INTERIM ADVICE NOTE LRDP 016

Future Proofing of Rural Roads

Project: Local Roads and Drainage Programme

IAN#: PMC-IAN-DES-016

Figure 4-1: Sample Typical Cross Section for Rural Arterial with Buffer Zones

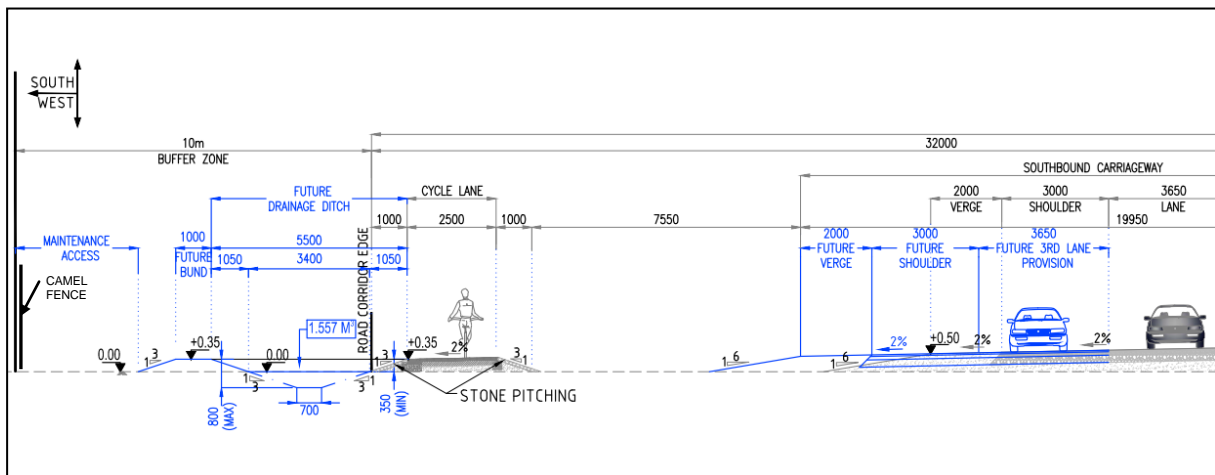
Figure 4-1 contains an example of a typical cross section for a Rural Arterial Road that the designer may consider that includes a 10m buffer zone for the provision of future drainage containment ditch and a maintenance access road.
